REVIEW 0 CLOSURE / POST CLOSURE \$ FOR

SERVICIOS CARBAPON INC (SOURCE PART B; 11/1/84)

COMMERCIAL FACILITY INFORMATION REQUEST

FIGURE E-4
MAP OF SCI SHOWING LOCATION OF
GROUNDWATER DETECTION
MONITORING WELLS

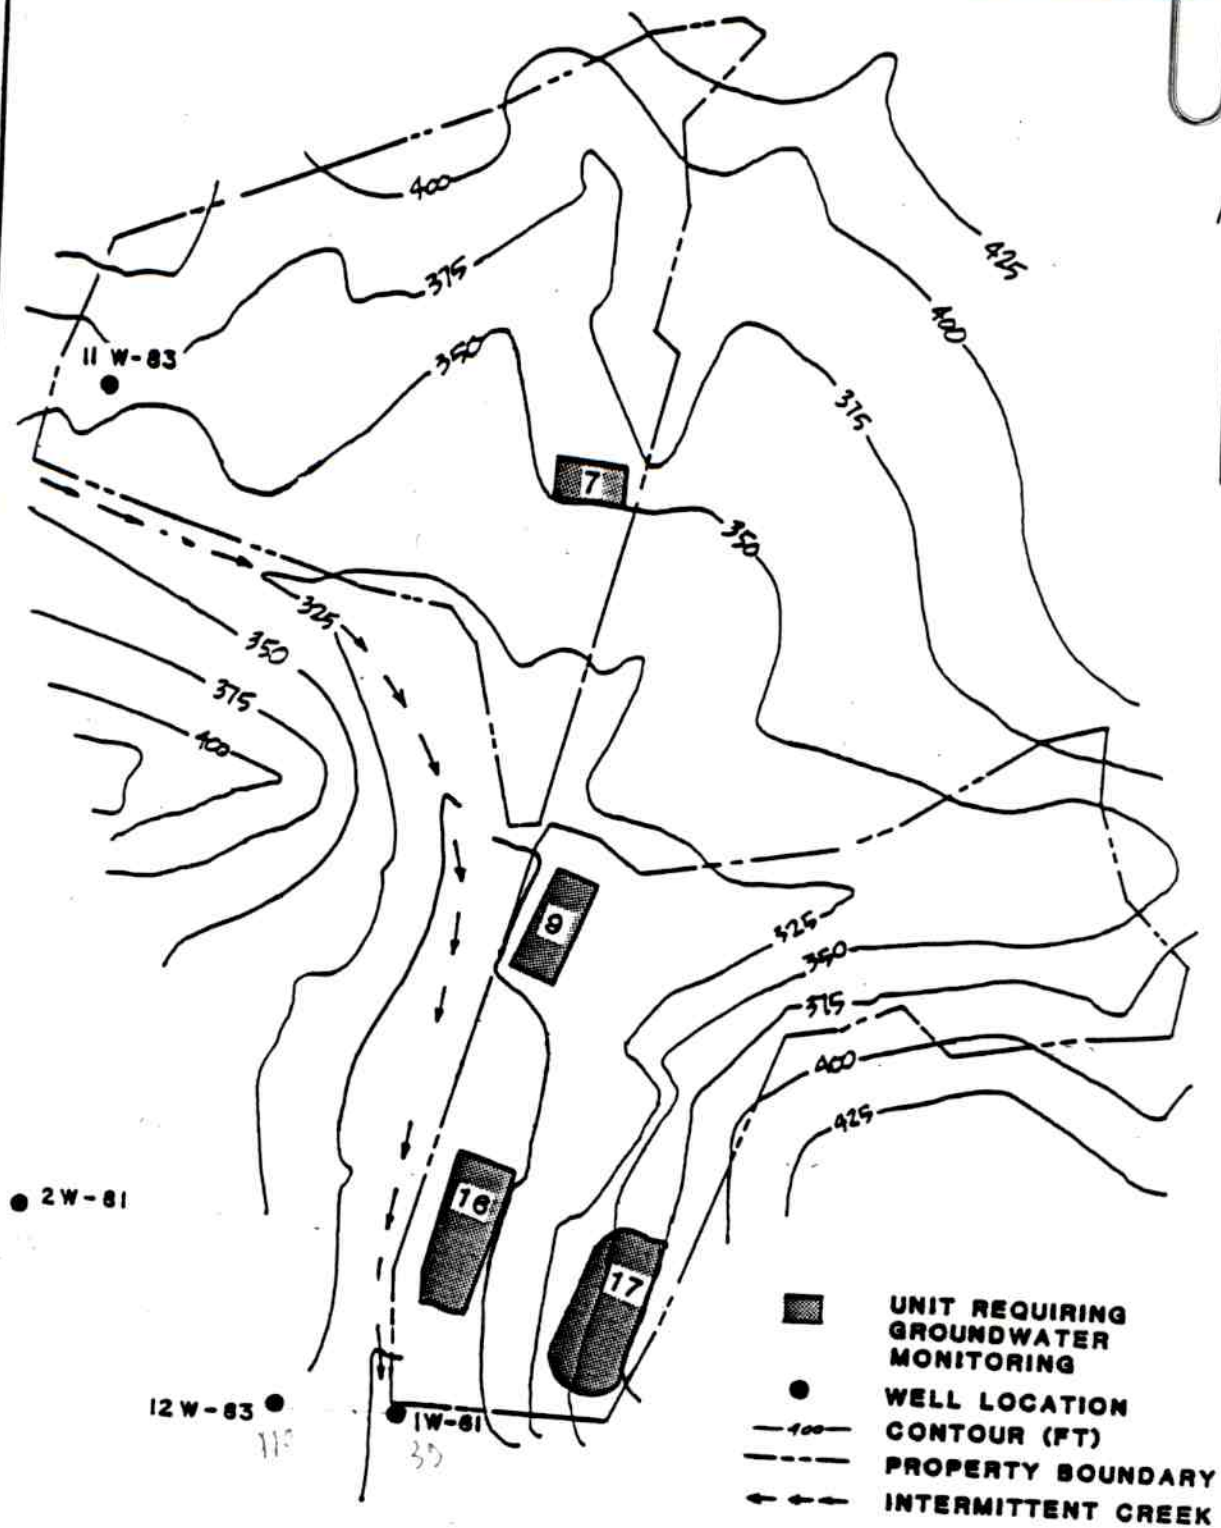
1. Is the facility operating under (check one):
Detection monitoring ☒
Assessment monitoring ☐
Waiver ☐
2. If the facility is operating under detection monitoring, what is the overall Regional evaluation of the effectiveness of the GWM system for the facility (i.e., can the monitoring system immediately detect migration of fluids from the waste management area?)
 - Need more wells? Yes ☒ No ☐
 - Need more wells to effectively monitor interconnected aquifers?
Yes ☐ No ☐
 - Need to improve well construction? Yes ☒ No ☐
 - Need to improve sampling procedures? Yes ☒ No ☐

- # of units at facility 18
- # of units under RCRA regulations ~~18~~ 17 Average size _____
- # of units not under RCRA 0 Average size _____
(closed prior to 11/19/80)
- Has the owner/operator closed any units at the facility?
(please identify the location of closed units on the site
map, H.3)
- Total # of ground-water monitoring wells upgradient 1
- Total # of ground-water monitoring wells downgradient 3
- Average distance of downgradient wells to waste-management
boundary ≈ 100 meters
